PROPERTY: WAHROONGA ADVENTIST SCHOOL, FOX VALLEY ROAD, WAHROONGA
APPLICATION NUMBER: SSD 12_5535
PROPOSED DEVELOPMENT: SCHOOL (Kindergarten to Year 12)

Attachment A:

Figure 1: Incremental impacts to the open space provision and relationship to school showing extrapolated overlay information:

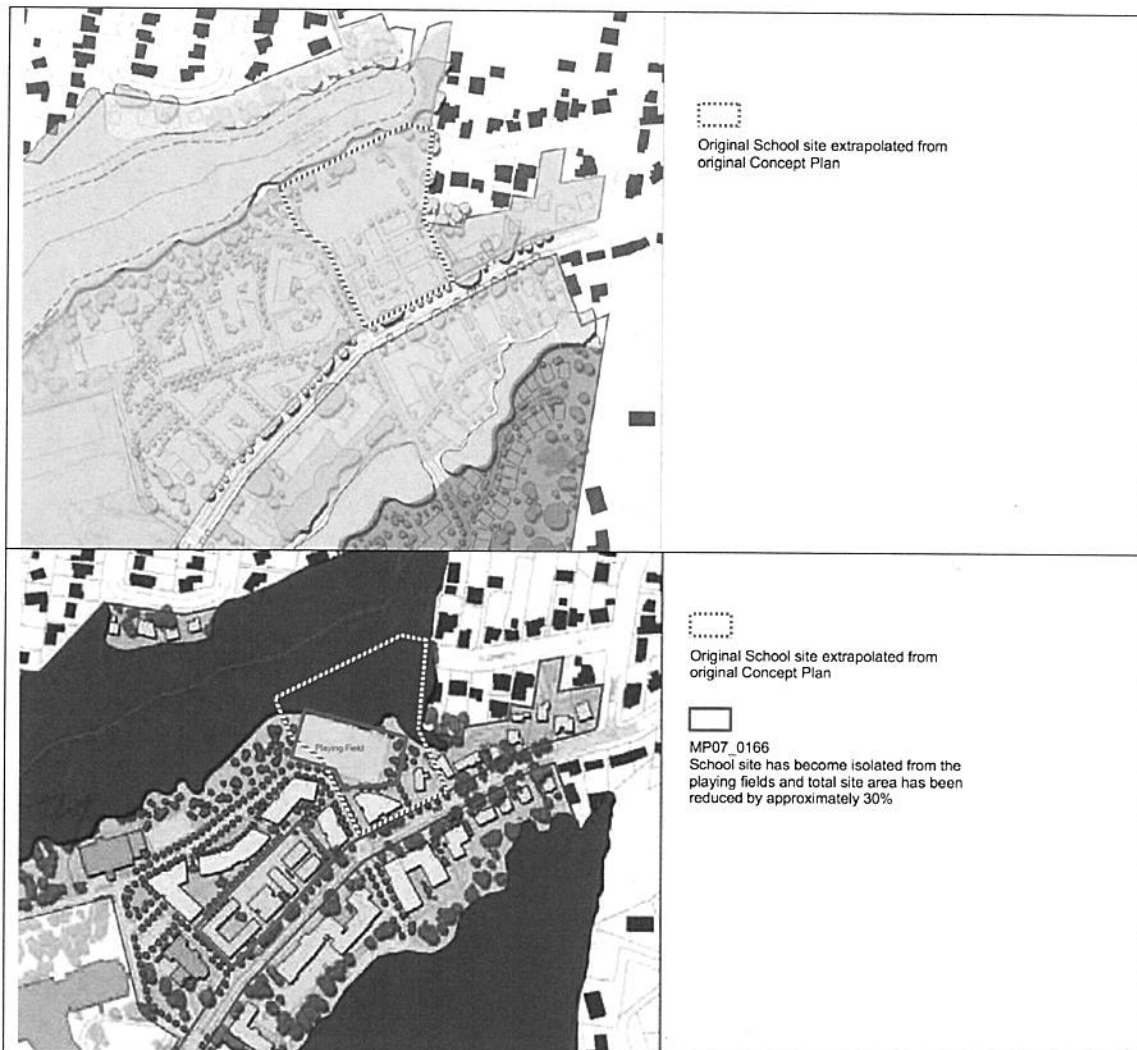
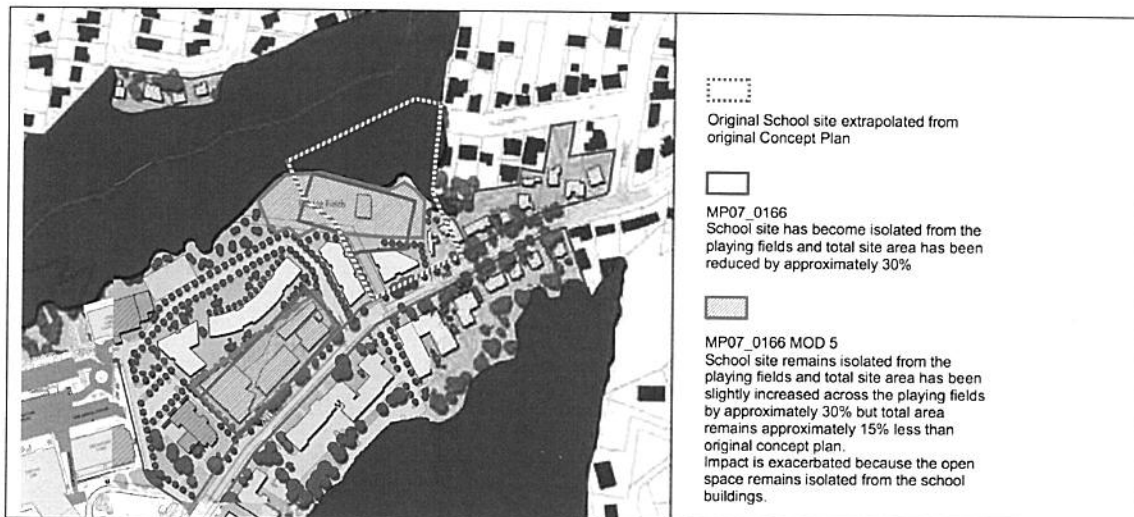
This landscape performance objective for the educational precincts remains valid. Figure 1 (over page), demonstrates the incremental impact of the site arrangement and spatial allocation to the school site over the course of the Wahroonga Estate design.

Council requested details of spatial allocations of useable outdoor space in 'submissions during the MOD5 application. This was not provided in the proponent's response to submissions and has not been provided in the project application. Proposed useable outdoor space provision is to be demonstrated both graphically and as a per/child spatial allocation on Lot 1.

Our comparisons of both public and private primary and secondary schools of comparable size within the Ku-ring-gai LGA demonstrate in all cases that open space forms a significantly larger percentage of available site area than is proposed in the subject application. Indeed, the existing primary school provides approximately 2000m² more site area than is proposed for the new school. This reinforces the need for further amendments to the proposed developments as the existing school on a larger site is meeting the needs only of primary school children whereas the new school needs to address outdoor spaces for the complete range of school ages while being proposed on a significantly smaller site. This is not supported.

As a primarily 'greenfield' site within a low density surrounding urban context characterised by bushland, tall trees and large gardens, the deficiencies in open space/accessible outdoor playing areas for the school both in site arrangement and allocation cannot be supported.
